Mixed-Use Development
2 Mark Street & 1-3 Marsden Street, Lidcombe NSW 2141

Development Application

to approved DA 2022 / 0253

DA - B	DRAWINGS UPDATED IN RESPONSE TO DEAP MEETING & COUNCIL RFI (June 2025)	19/08/2025	YT	AHM
DA - A	ISSUED FOR DEVELOPMENT APPLICATION	17/02/2025	YT	AHM
DA - P.3	ISSUED FOR DEAP MEETING	18/06/2024	YT	AHM
ISSUE	AMENDMENT	DATE	DRAWN	CHECKED
Drawing is NOT VALID or issued for use, unless checked.

SHEET TITLE:
Internal Elevations

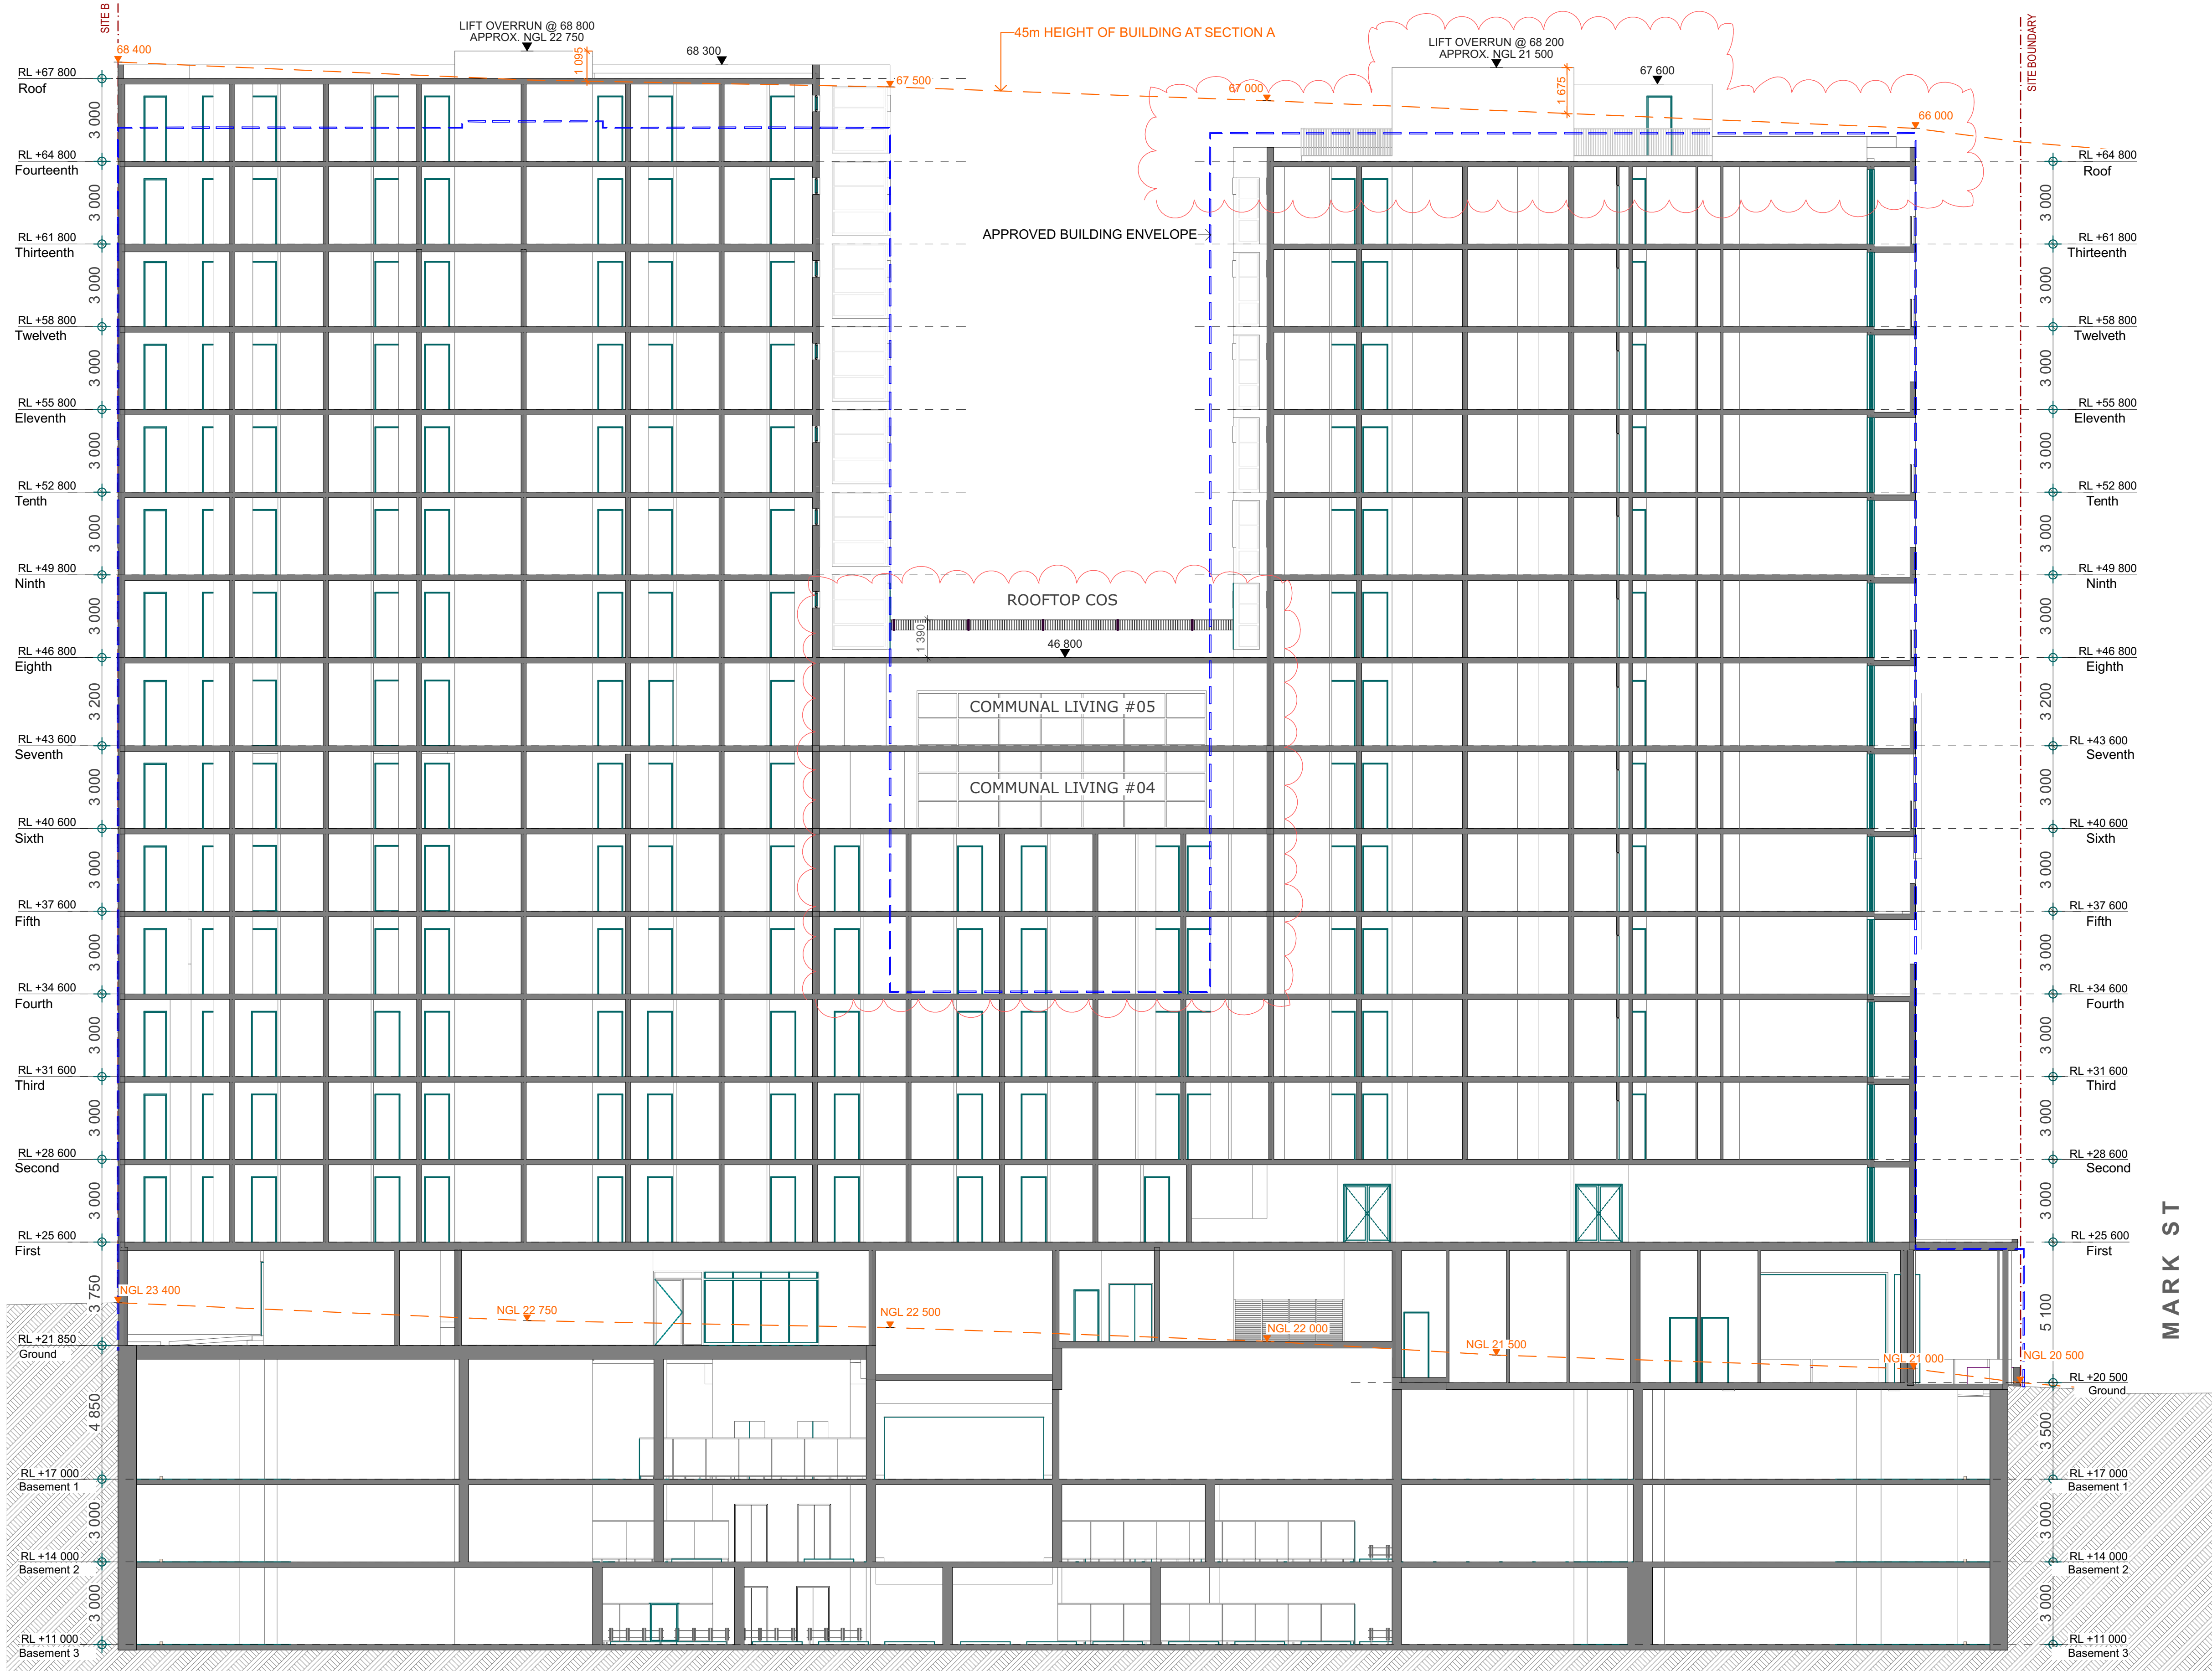
- Level 14 residential component at western tower deleted. Infill/add one floor to middle section of building
- New rooftop terrace on Level 8
- Floor to floor height to GF & Level 7 increased, floor RL's updated
- Facades updated. New materials introduced as shown clouded

SHEET TITLE: Section A

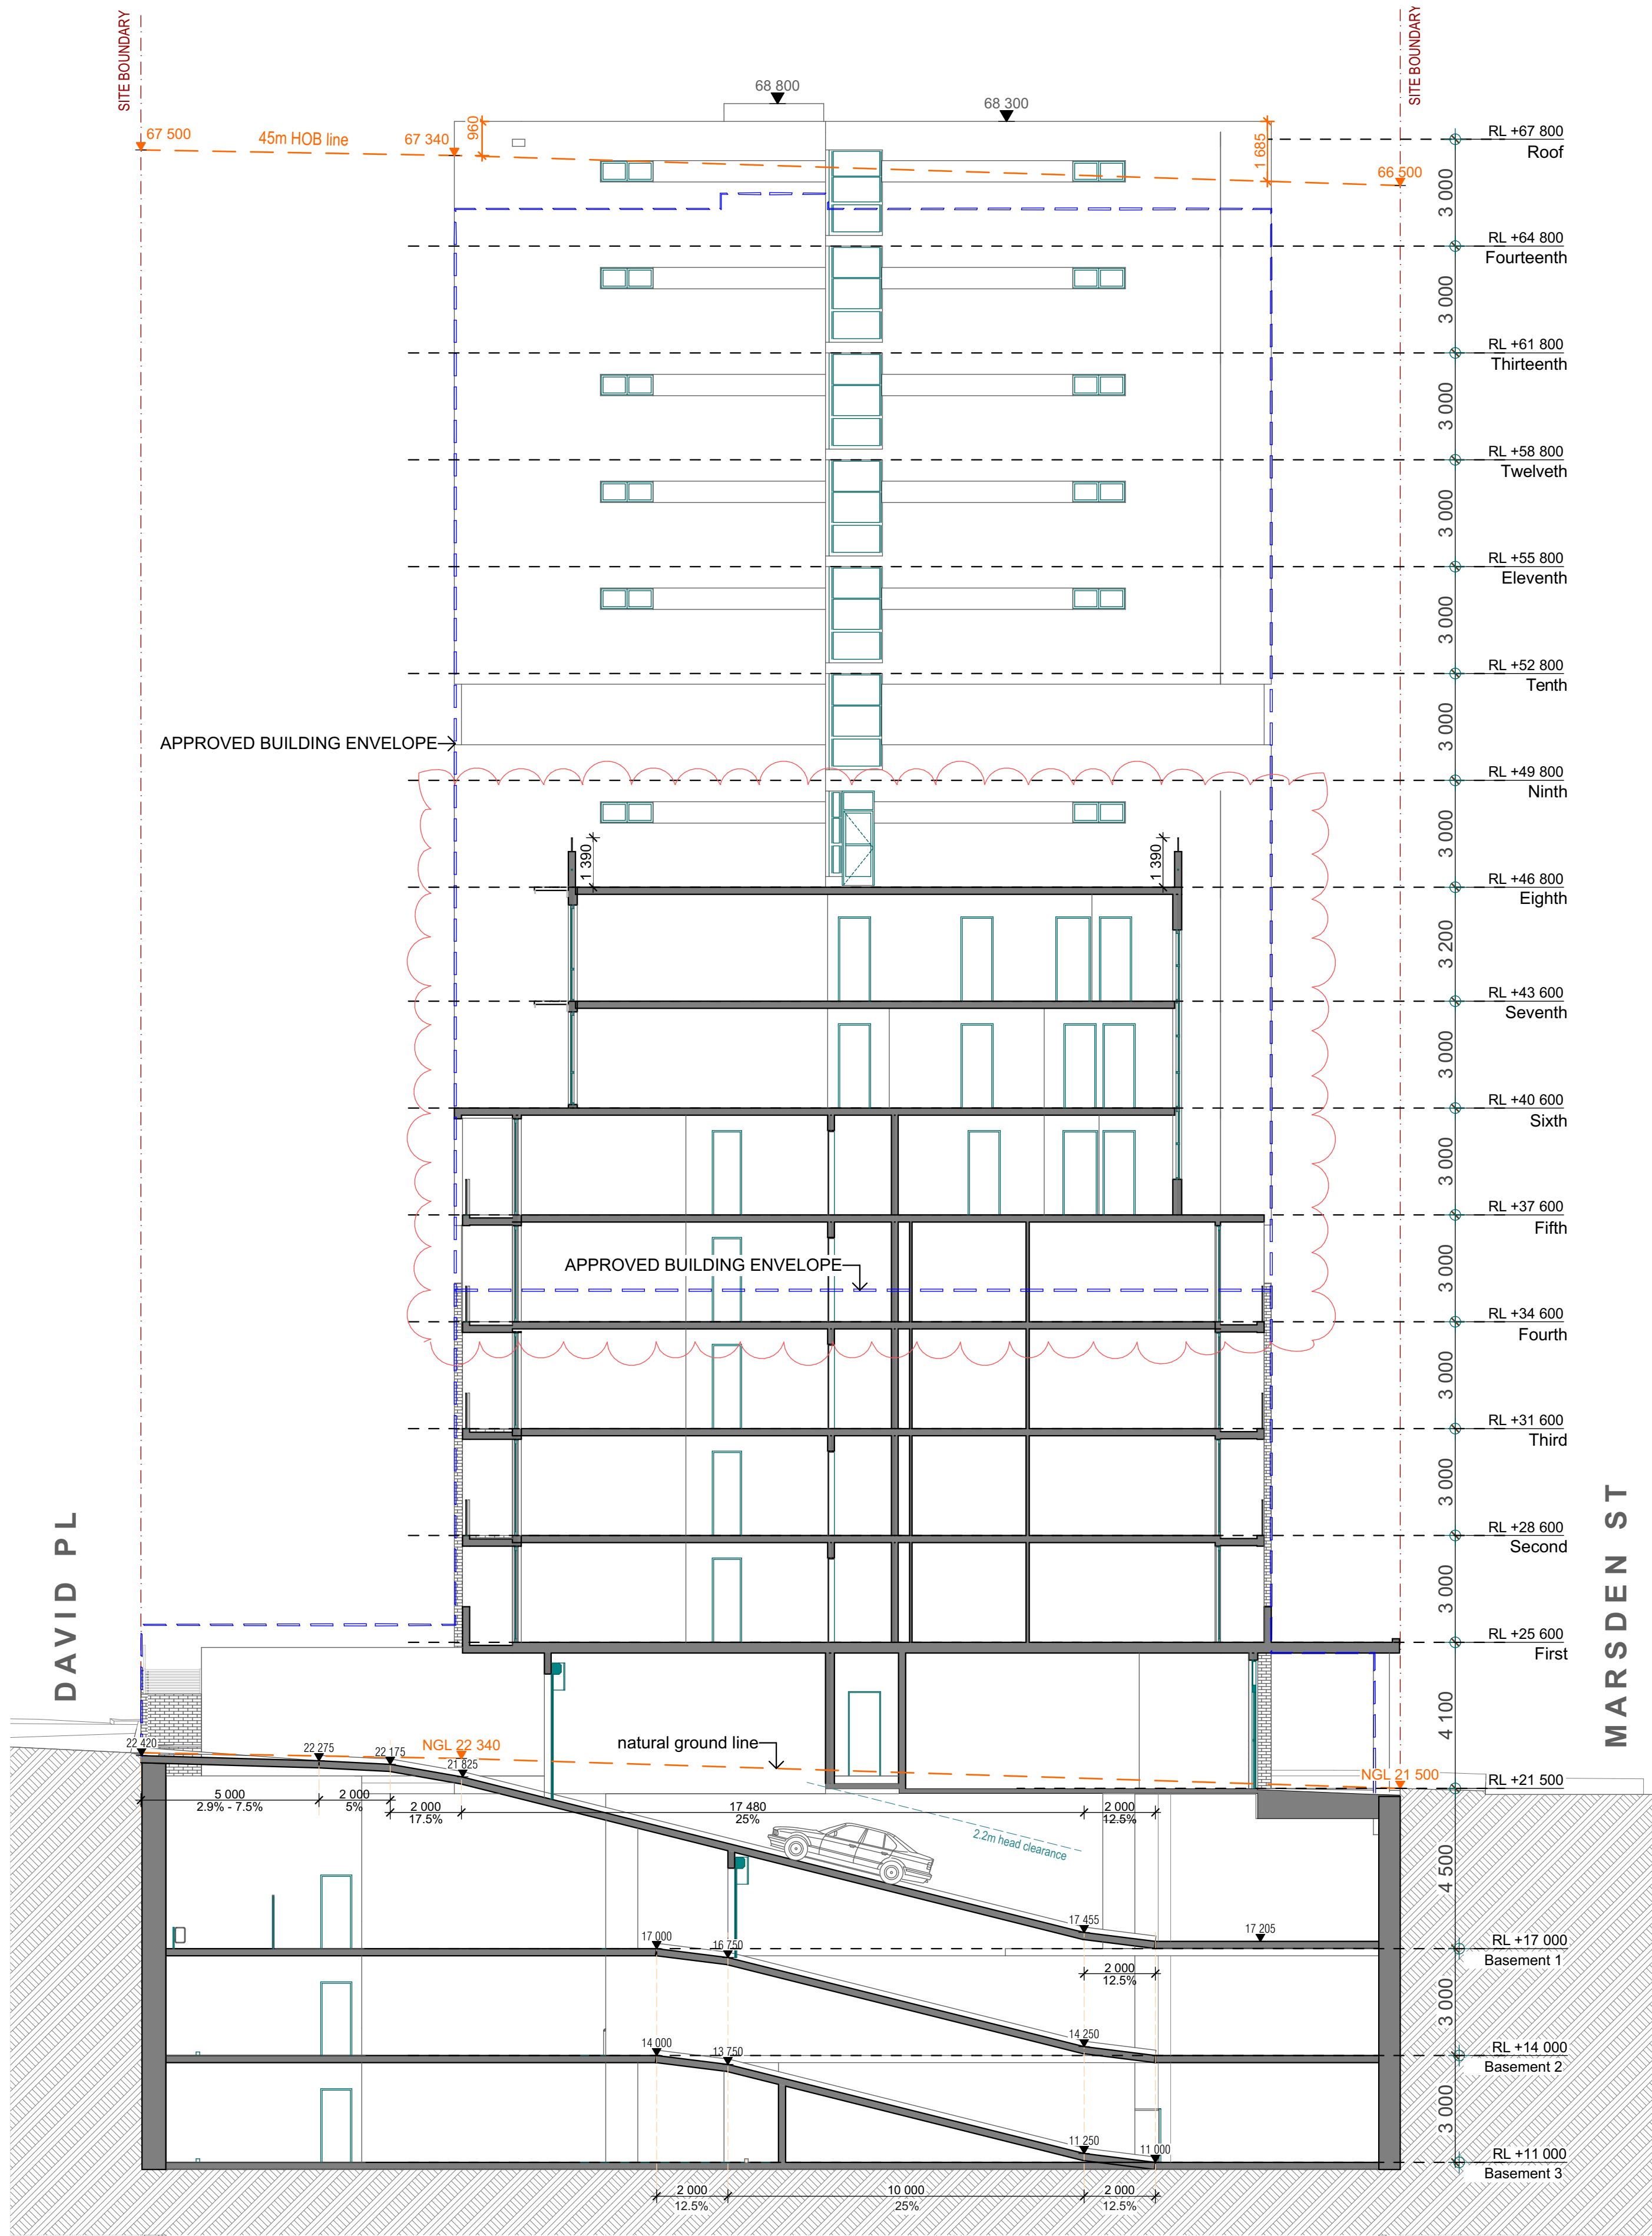
- Level 14 residential component at western tower deleted. Infill/add one floor to middle section of building
- New rooftop terrace on Level 8
- Floor to floor height to GF & Level 7 increased, RL's updated

1 Section B
scale 1:250 @ A3

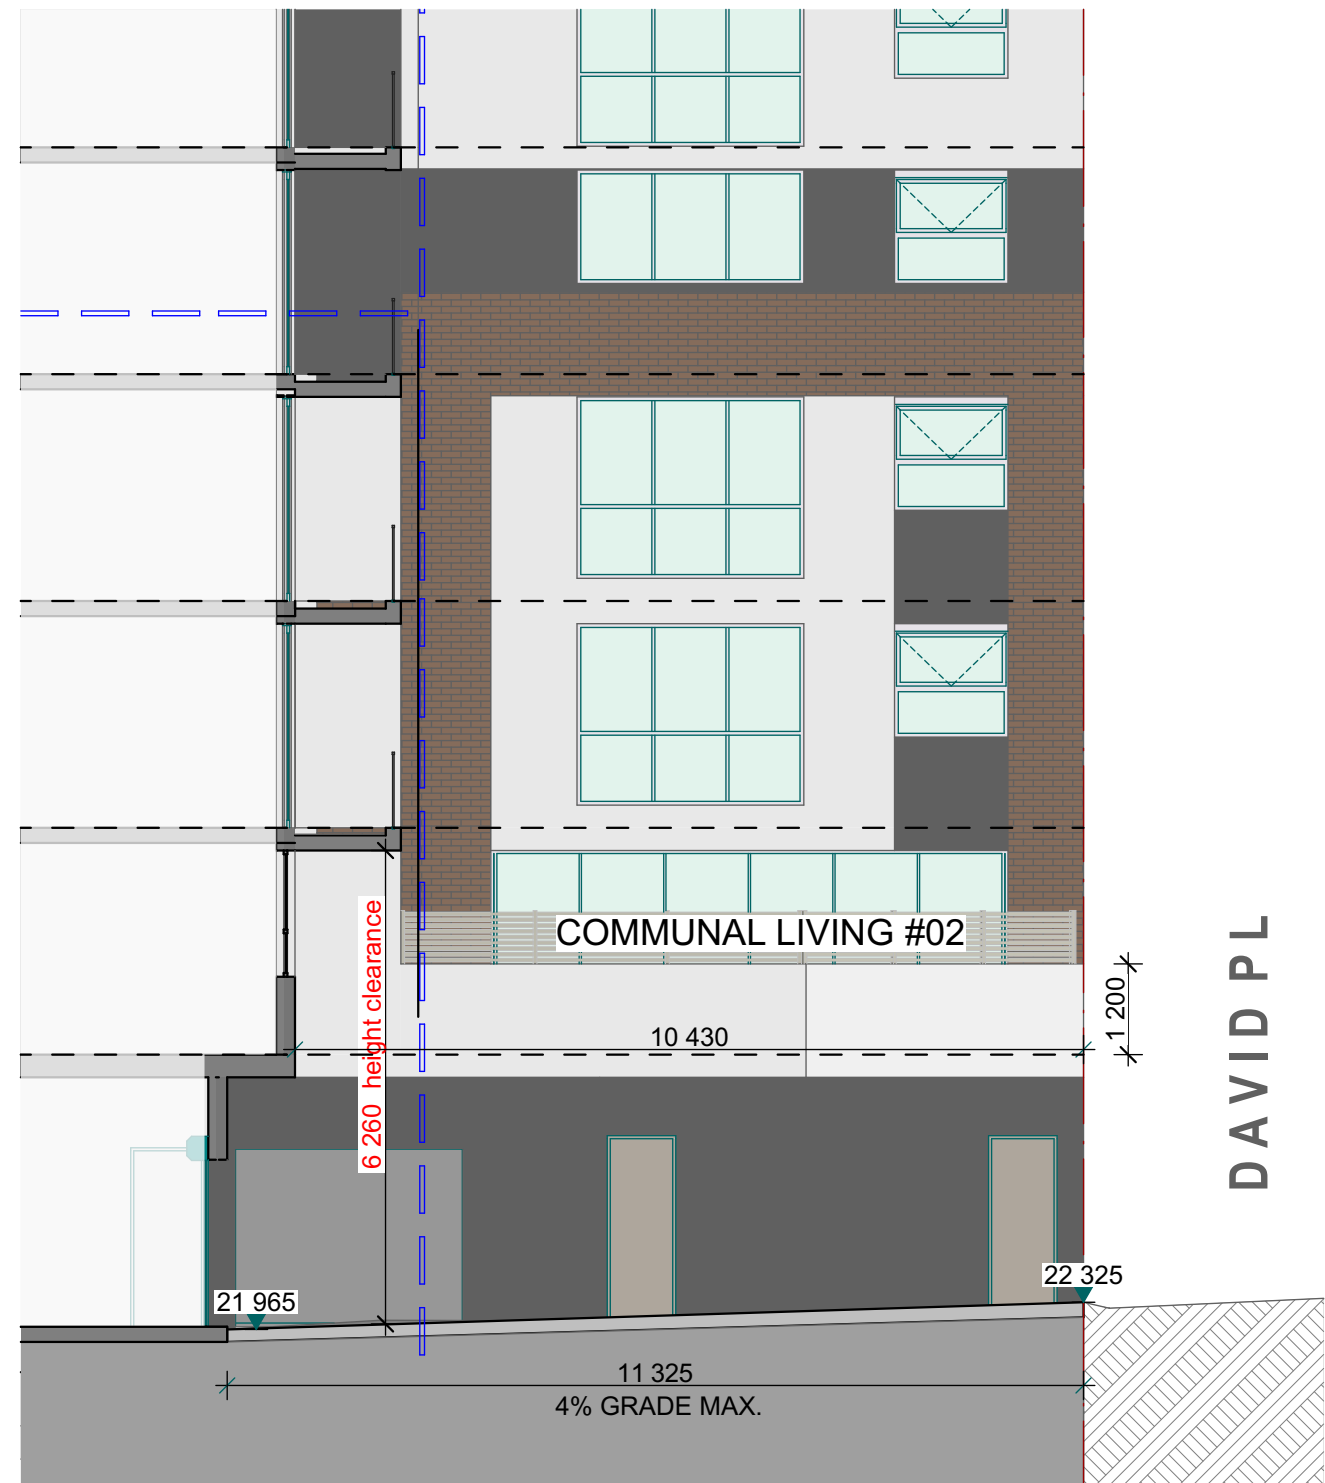
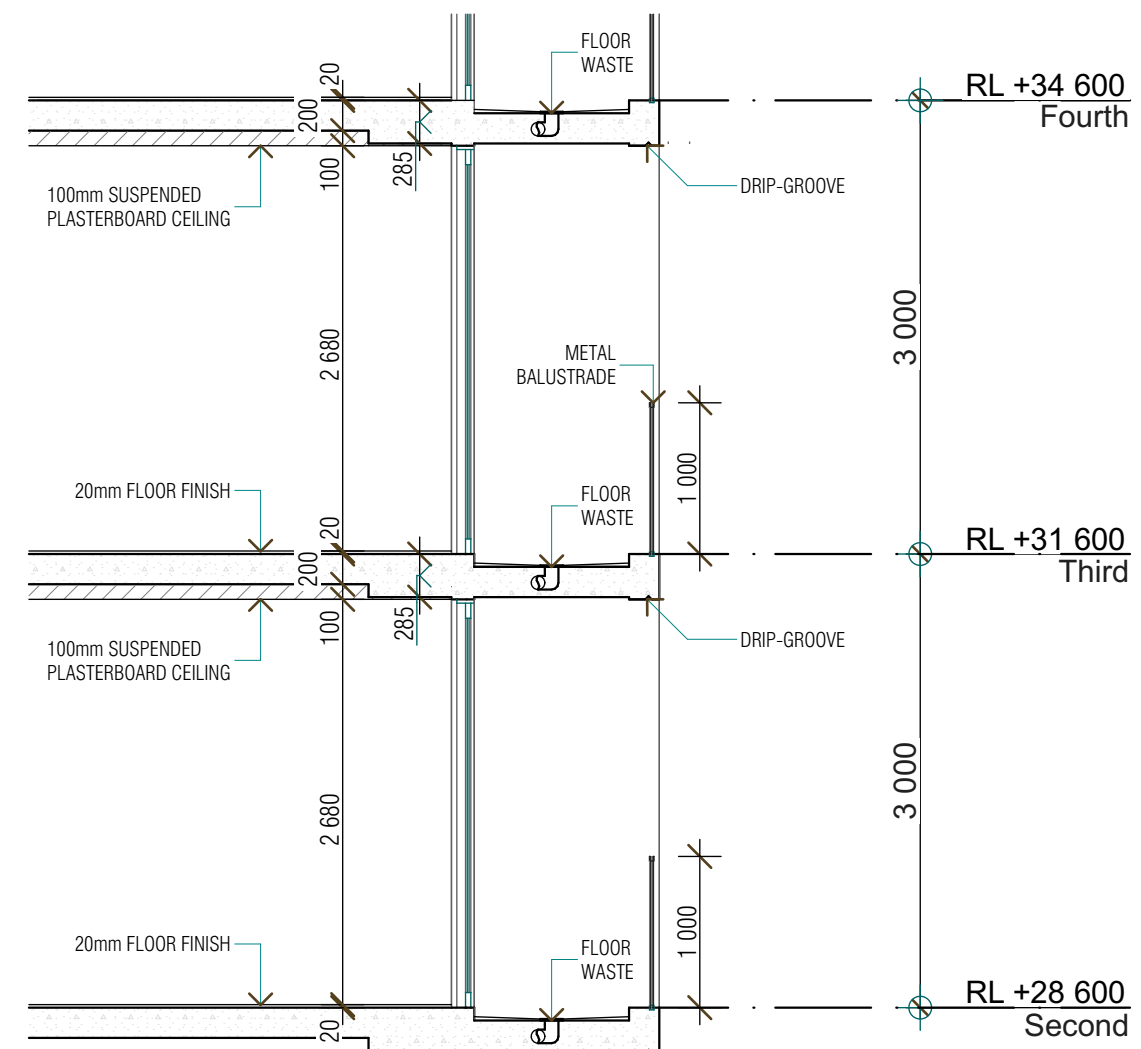
- Level 14 residential component at western tower deleted.
- Infill/add one floor to middle section of building
- New rooftop terrace on Level 8
- Floor to floor height to GF & Level 7 increased, RL's updated
